Re: ACTION RE: PETITION FROM SURGERY CENTER OF GREEN BAY – SITE PLAN AND DESIGN REVIEW ON PARCEL AL-2127, LOCATED AT 2825 S WEBSTER AVENUE

Date: 22 February 2017

Site Plan & Design Review – Staff Comments

RE: Site Plan Reviewer comments for the new Surgery Center of Green Bay located at 2825 South Webster Ave.

ARCHITECTURAL
SITE PLAN

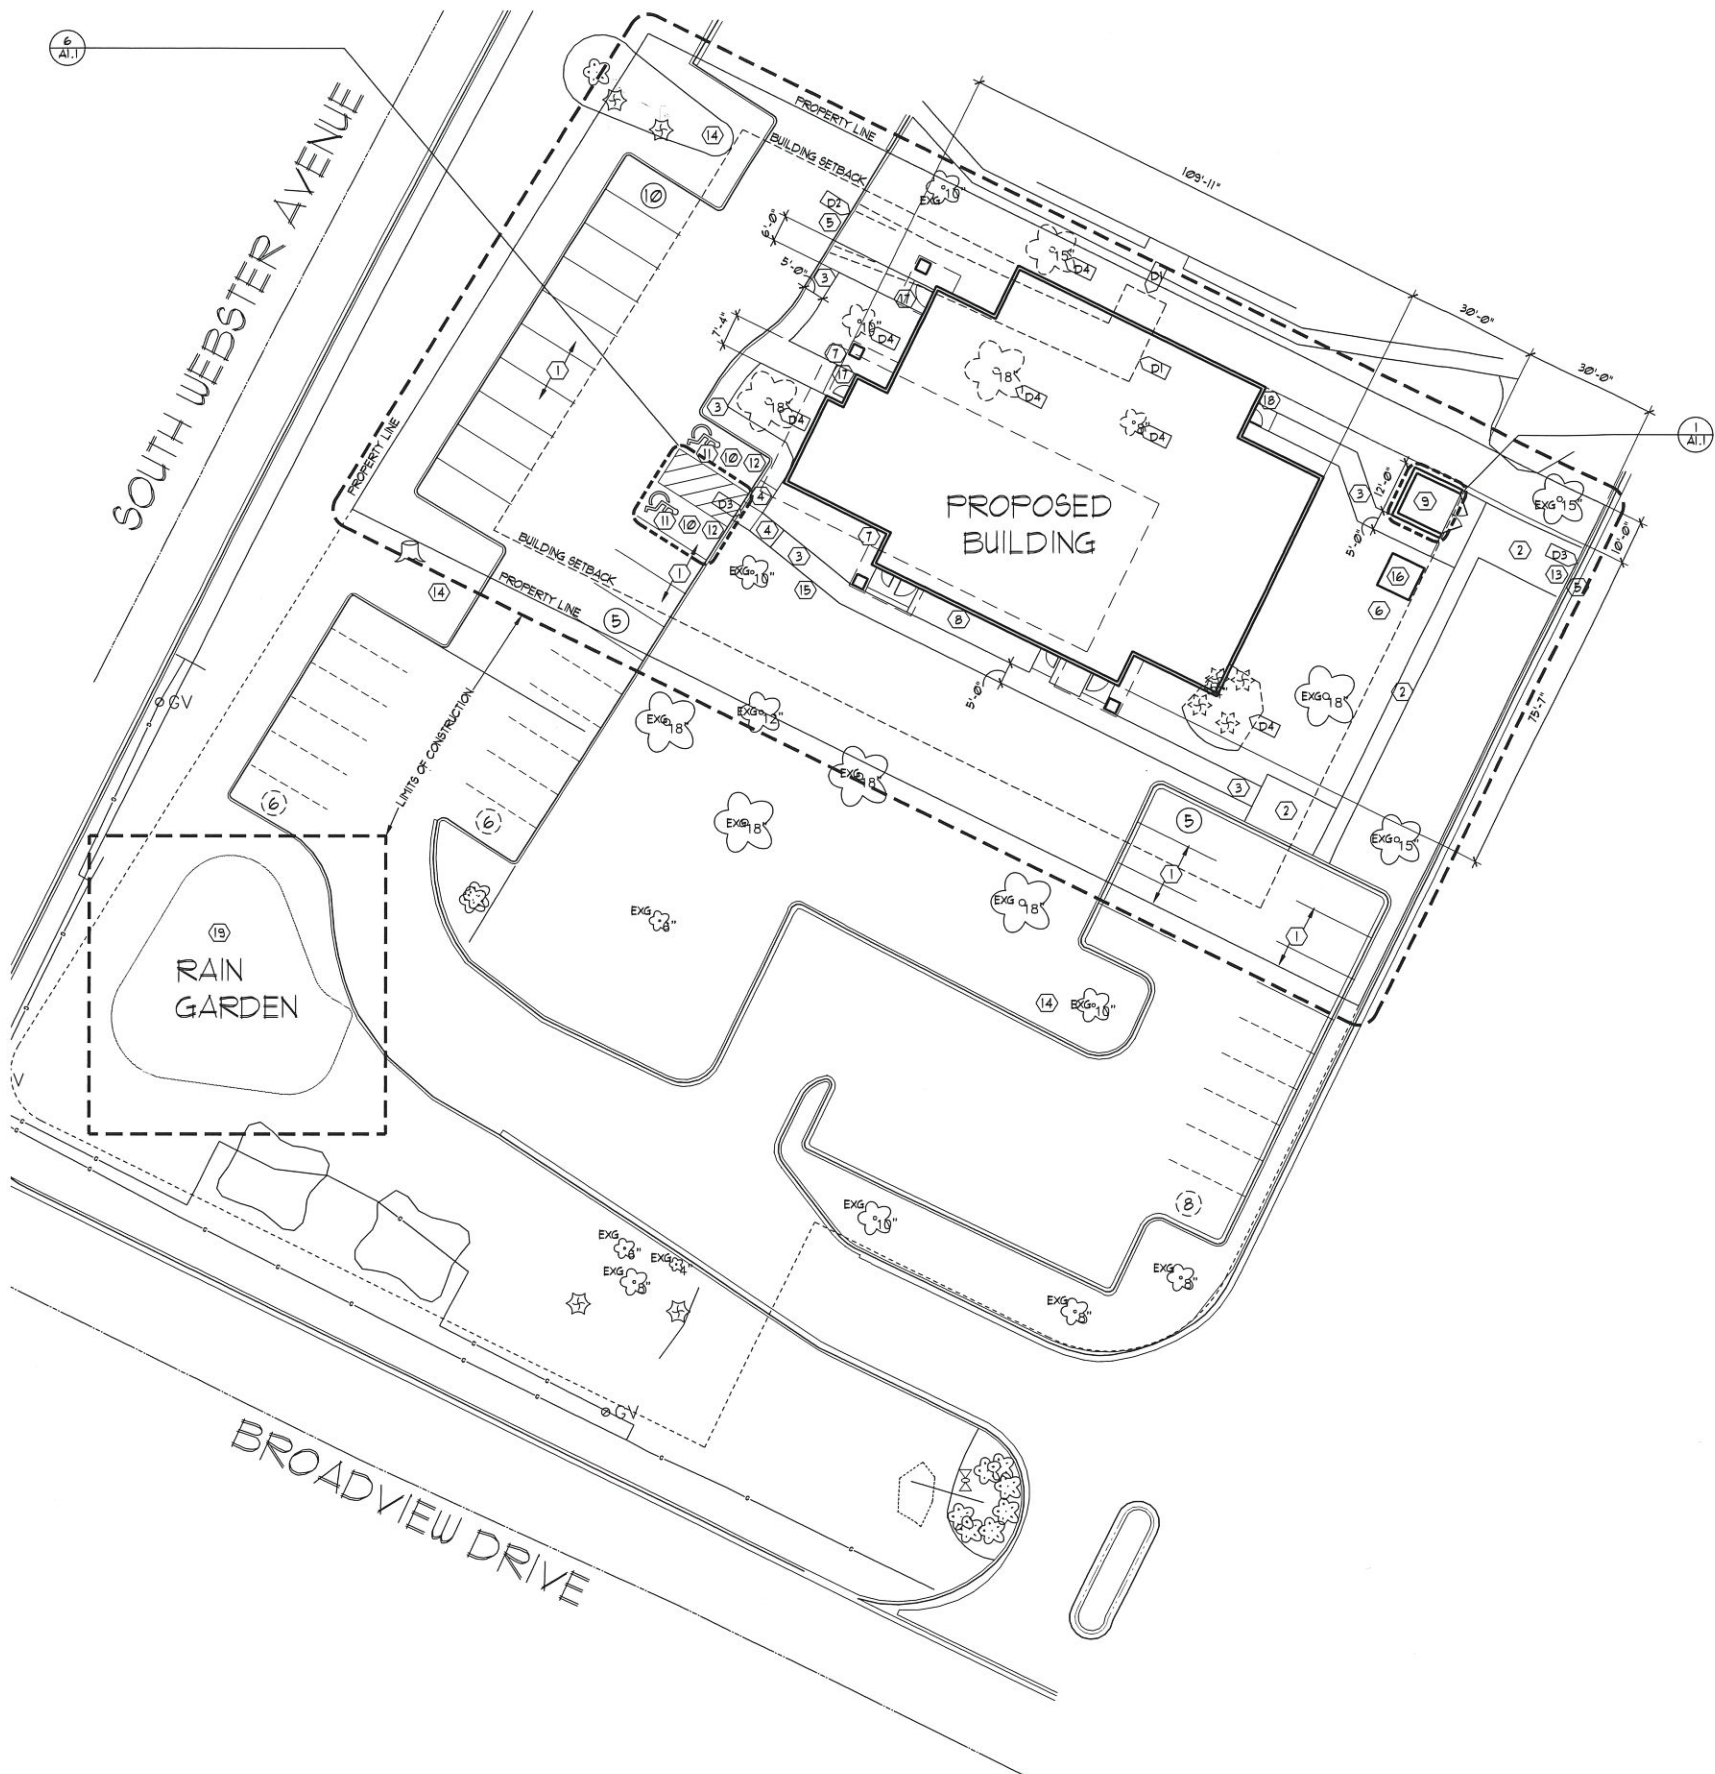
Zoning district		"C" Professional Office and Residence District		
Building use (allowed)		Medical Office/Clinic		
		Required	Provided	Notes
Height		Lesser of 40' or 3 stories	Not provided	
Lot	Area	7,500SF	31,562SF	
	Frontage	100'	127.25'	Measurement based on Brown County aerials. Should be noted on plans.
	Green space	20%	44%	
Setback	Front	50'	72'	Calculation based on Brown County aerials. Should be noted on plans.
	Side (inner)	10'	10'	
	Side (corner)	N/A	N/A	
	Rear	30'	60'	
Parking	Number	1.5/200SF + 1per employee on shift: 44	21 (on site)	Additional 28 stalls on adjoining parcel. Perpetual parking easement agreement between parcels should be established.
	Size	10'x20'	Not provided	Stall size is allowed regardless if existing kept.
	Bicycle	Bicycle parking should be provided	Standards met	Recommend a bicycle rack which accommodates a U-shaped lock and the ability to secure the bike frame and both wheels instead of proposed. Also maintain the rack out of the pedestrian zone.

Access	Automobile	24' drive lanes with 90 degree parking	Not provided	Perpetual ingress/egress easement agreement between parcels should be provided. Lane width is allowed regardless if existing kept.
	Pedestrian	ADA compliant sidewalks	Standards met	Sidewalk widths should be noted on plans. Pedestrian access from Webster Avenue or Broadview Drive is recommended.
Architecture		Varied rooflines and other architectural designs that break-up the building mass	Standards met	
Exterior finishes		Brick, stone, glass, fiber cement siding, EFIS, stucco, wood siding	Not provided	
Lighting		Dark sky compliant, no light directed towards ROW, no more than 0.5FC at property line, must be shut off at 10p.m.	Standards met	There is a slight spillage of more than 0.5FC onto neighboring drive, which is acceptable. Staff recommends the full site lighting option.
Sign		N/A	N/A	Location should be identified, but design is reviewed at time of sign permit. Sign should be shut off at 10p.m. with lights.

Fences/Screening		No fences or berms are required, dumpster must be located at rear and be screened using same finishes as primary structure, mechanical equipment must be screened from street	Standards met, except for back-up generator	Back-up generator should be screened from view of the street to the greatest extent possible.
